**GARVEY COMMONS/
 SHERBURNE HALL
 ADDITIONS & REMODELING**
 ST. CLOUD STATE UNIVERSITY
 ST. CLOUD MINNESOTA

A-9

9 NEW CORRIDOR CROSS-SECTION
1/8" = 1'-0"

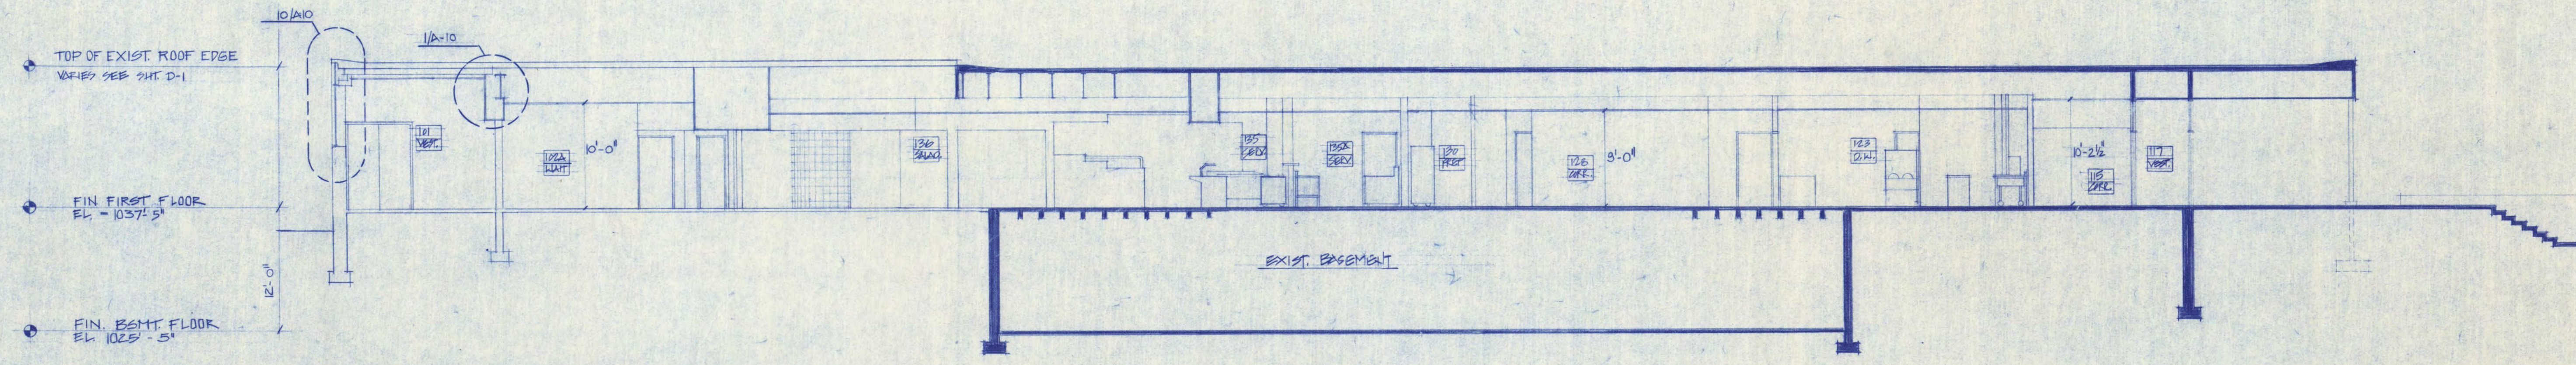
Sheet A-9
 112. Detail 9: The new wall to the right of the existing building wall is incorrectly drawn. See Detail 1/A-15, Reverse, for the proper condition.
 113. Detail 13: There is a wall and a footing missing to the right of the existing building wall; see Sheet A-4 and supplemental structural drawings issued with this Addendum for proper conditions.

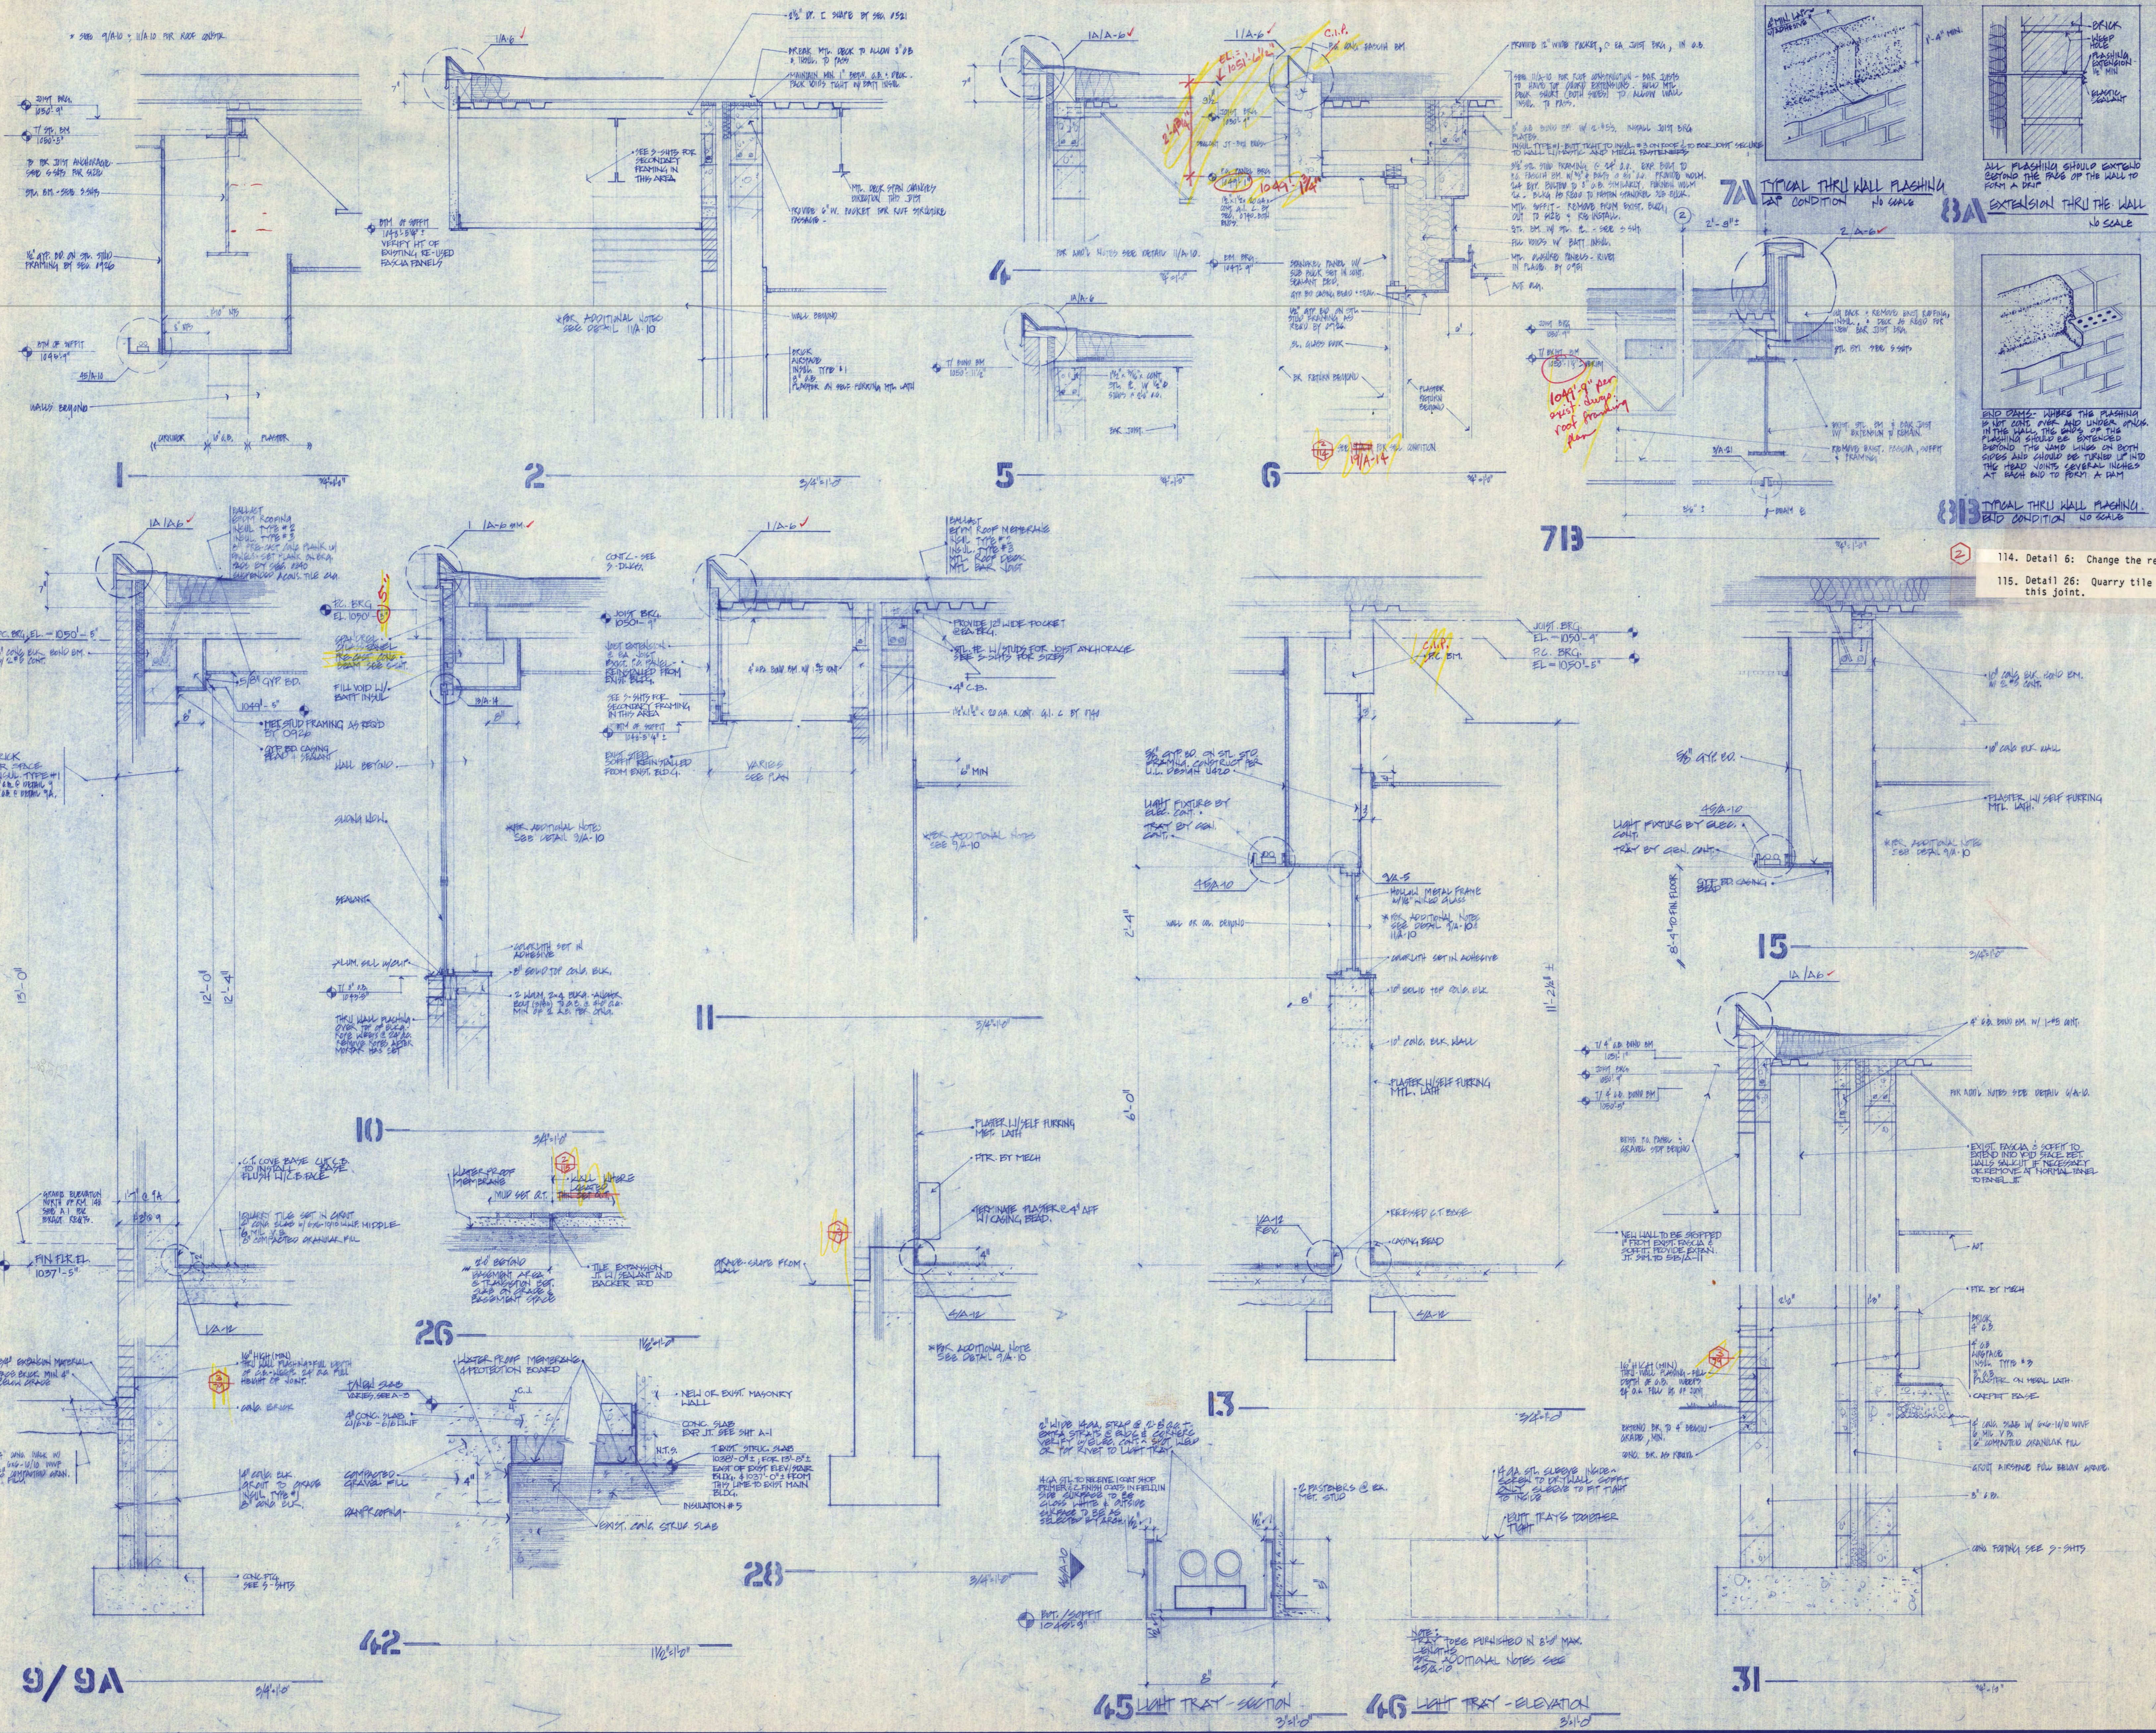
114. Detail 6: Change the reference to the sill condition to Detail 19/A-4.
115. Detail 26: Quarry tile shall be indicated as mud set at both sides of this joint.

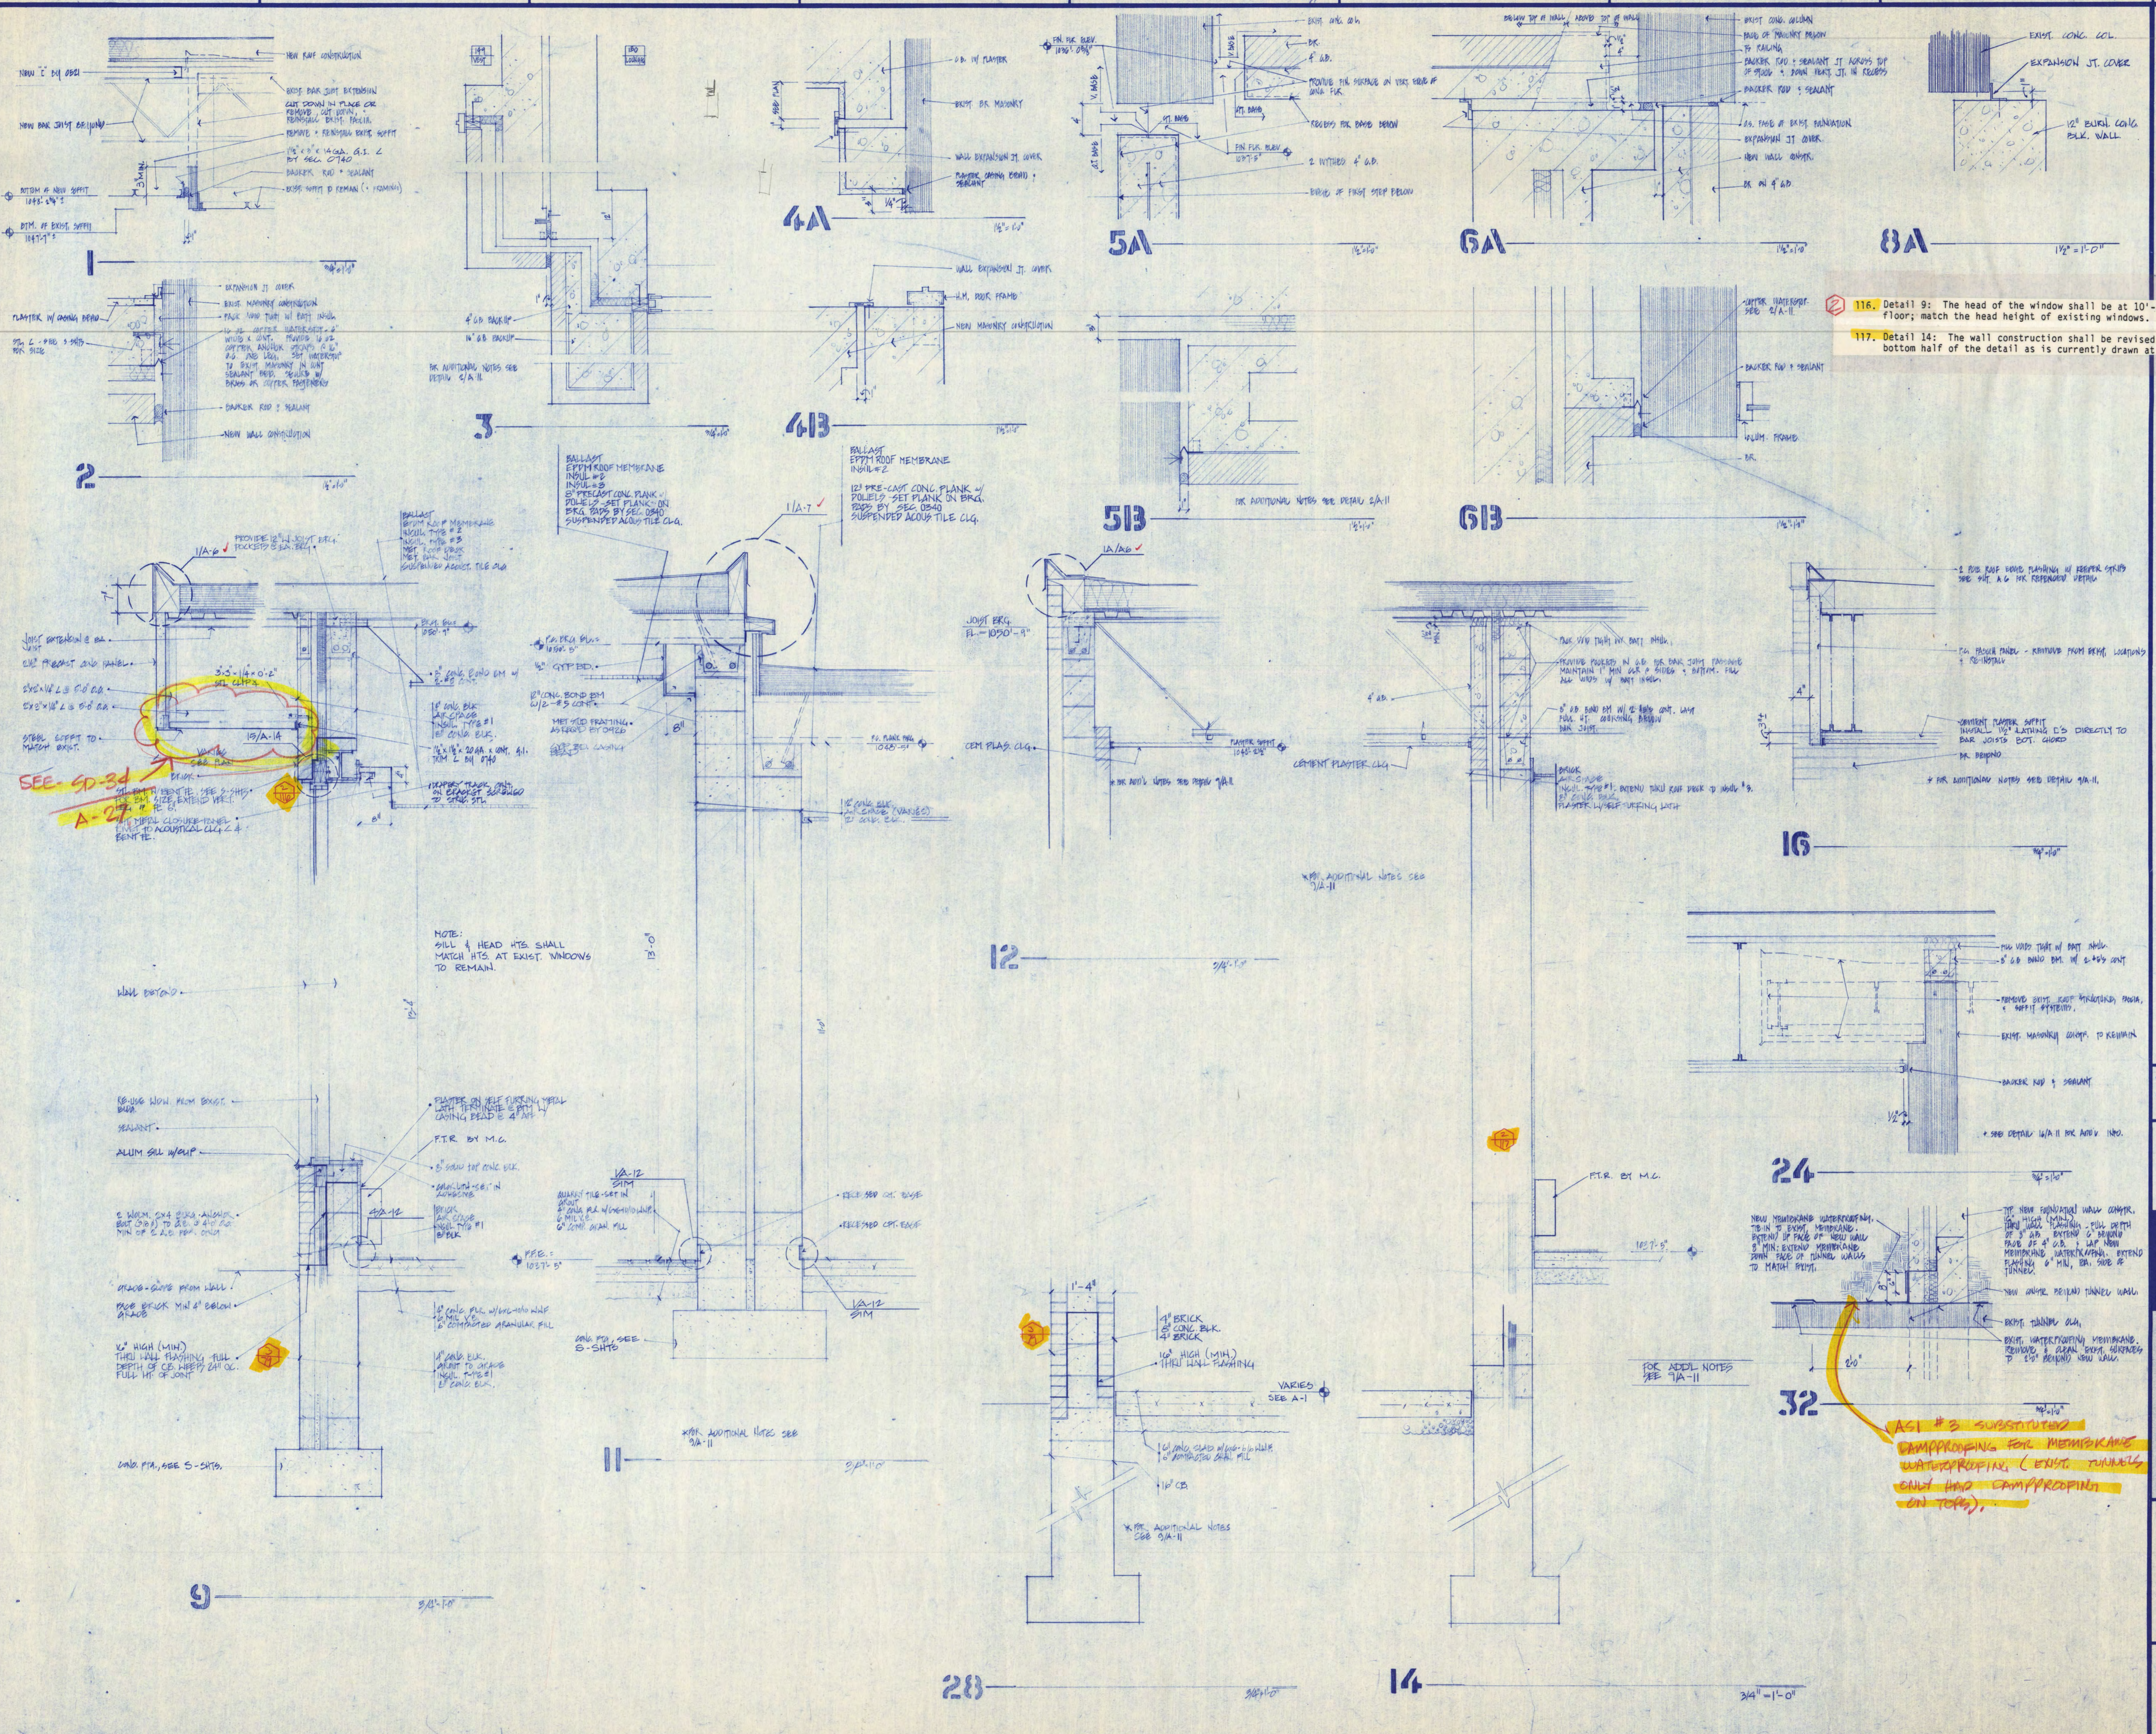
116. Detail 9: The head of the window shall be at 10'-2" ± above the finish floor; match the head height of existing windows.

117. Detail 14: The wall construction shall be revised to be the same as the bottom half of the detail as is currently drawn at the top half.
